Addendum No.: 6

Date Of Addendum: February 14, 2017

PHASE 1B ENHANCEMENTS  
SILVER SANDS STATE PARK  
MILFORD, CT  
BI – T – 604

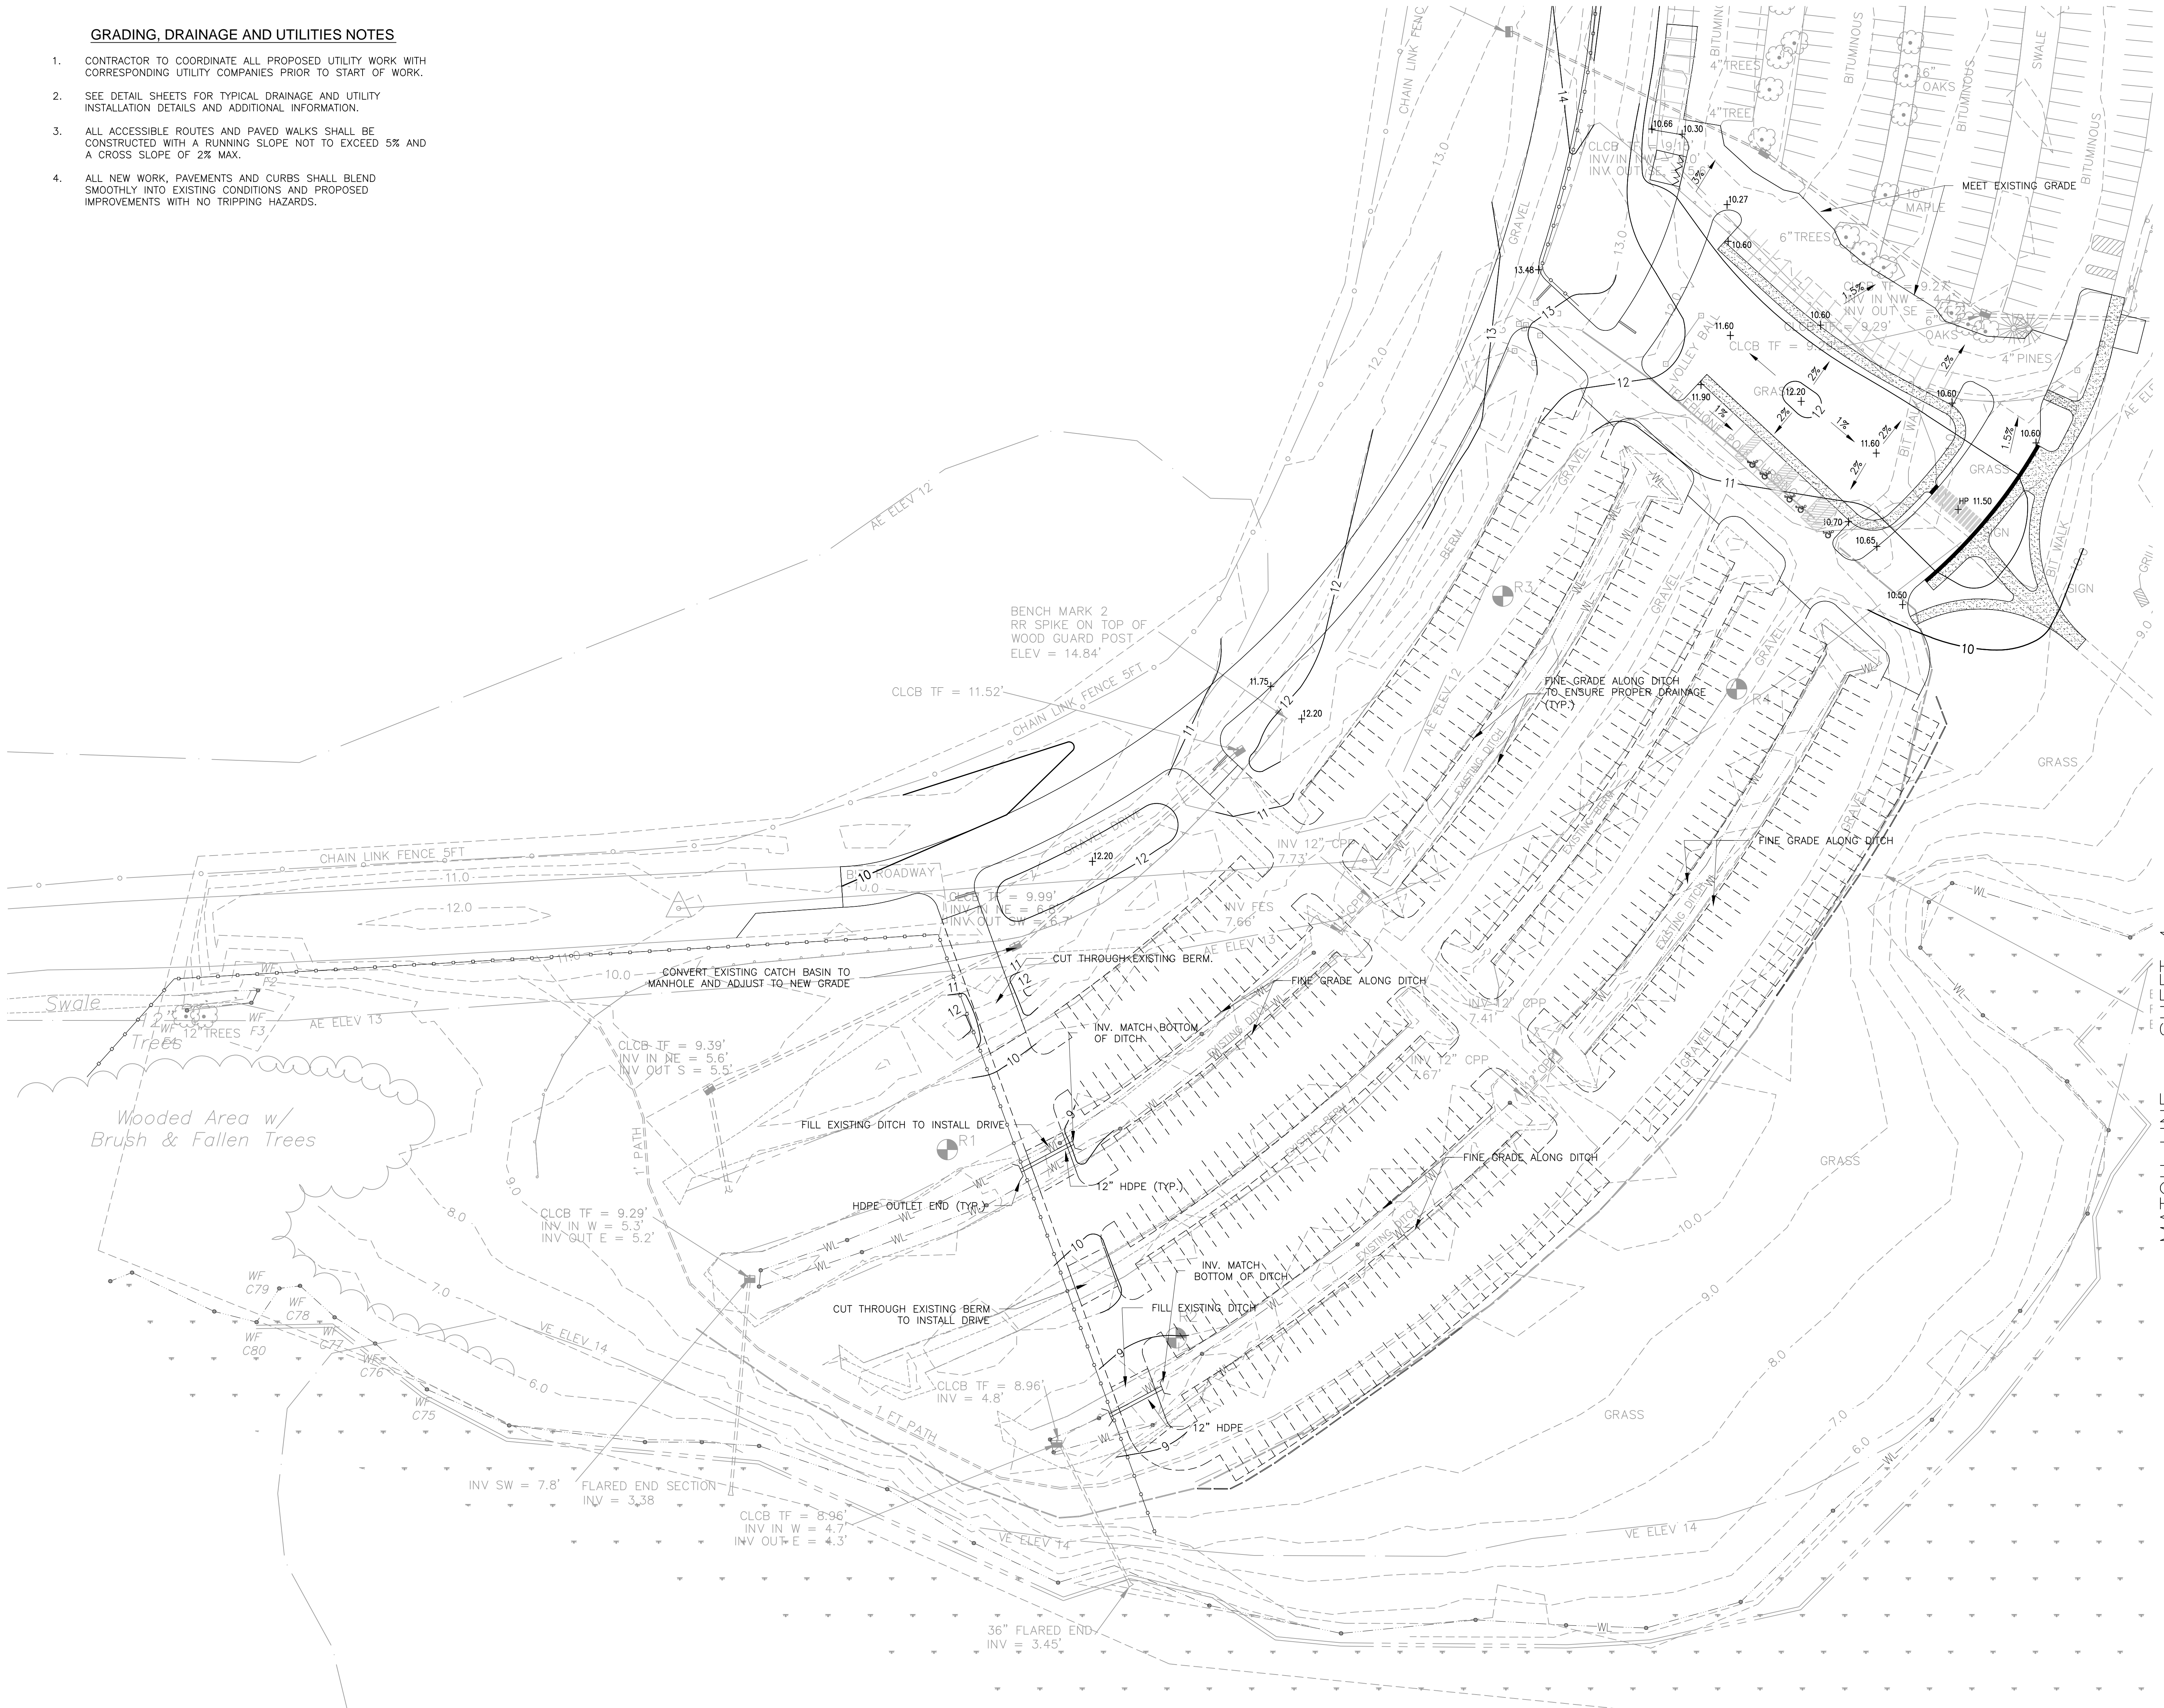
**QUESTION:** Refer to Drawing G-3 Grading, Drainage and Utility 3 of 5, there are Proposed Grades shown on this drawing however the existing grade(s)/ contours elevations are not shown throughout the work area(s) on this drawing. Due to the reconstruction of the existing main gravel road and portions of a "loop" road between the two main parking lots which are to be paved it is imperative we have a "completed" functional grading plan that shows both existing and proposed grades so an accurate earth work take off can be prepared for our bid.

Existing grades elevations have been turned on. Replace drawings G-1 thru G-5.
